TSB150177

New Two Wire Coolant Level Sensor Introduction

Figure 1, OEM Engineered Plastic Components (EPC) Connector

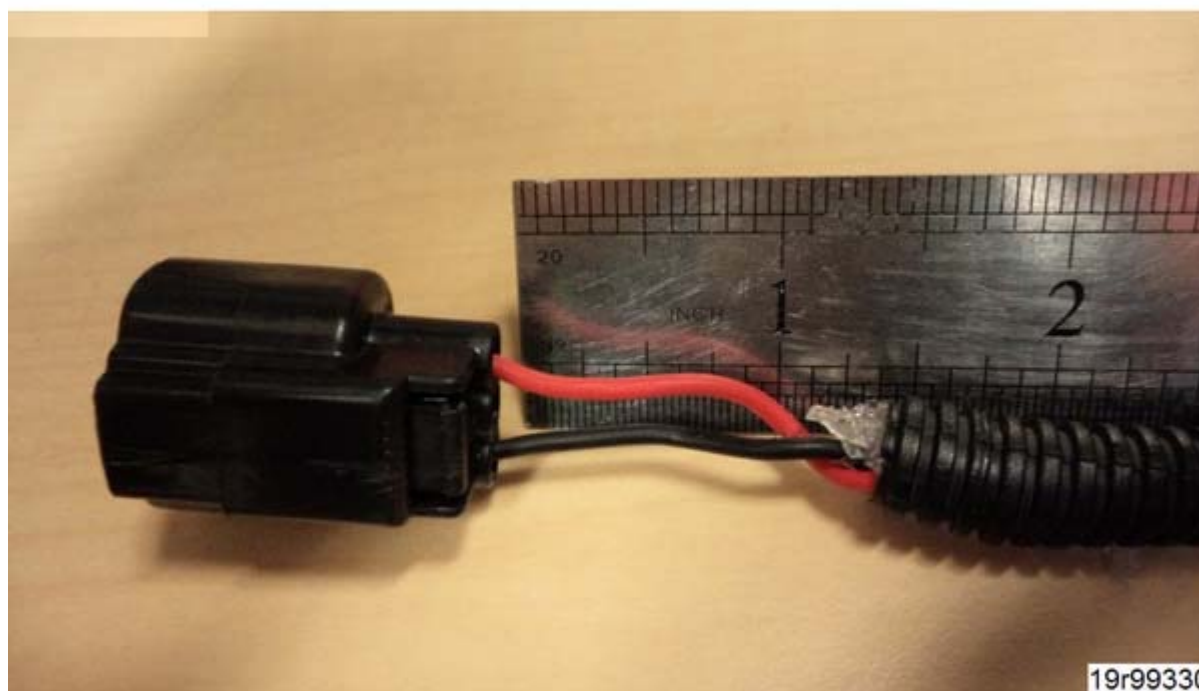
ISB6.7 CM2350 B101 and ISL9 CM2350 L101 equipped transit bus applications with coolant level sensor, Part Number 2872933, are experiencing pin corrosion as the result of poor sealing performance of the original equipment manufacturer (OEM) Engineered Plastic Components (EPC) connector.

- See the ISL9 CM2350 L101 Service Manual, Bulletin 4310787. [Refer to Procedure 019-017](#) in Section 19.
- Cut the OEM harness 25.4 mm [1 in] behind the OEM Engineered Plastic Components (EPC) connector. See Figure 1 below.

- Cut the OEM harness 25.4 mm [1 in] behind the OEM Engineered Plastic Components (EPC) connector. See Figure 1 below.
- Install electrical connector, Part Number 5299971. See Figure 2 below.

Figure 3, New Coolant Level Sensor for ISB6.7 CM2350 B101 and ISL9 CM2350 L101 Transit Applications, Part Number 4359193.

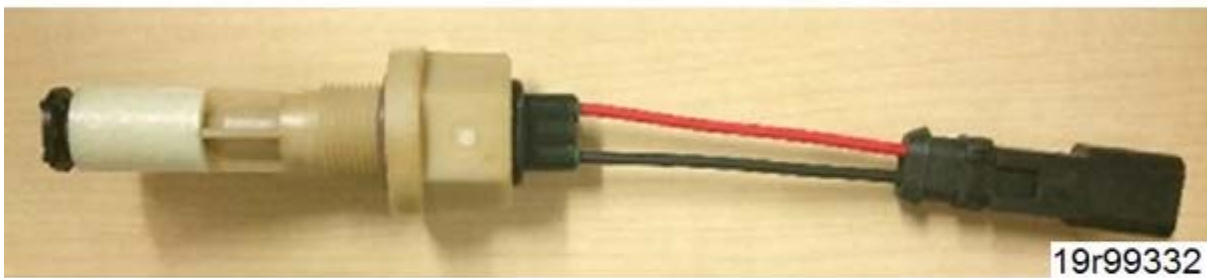
- See the ISL9 CM2350 L101 Service Manual, Bulletin 4310787. [Refer to Procedure 019-199](#) in Section 19. Reference Solder Splice section.
- Install new coolant level sensor, Part Number 4359193, into the surge tank and connect to electrical connector, Part Number 5299971. See Figure 3 below.
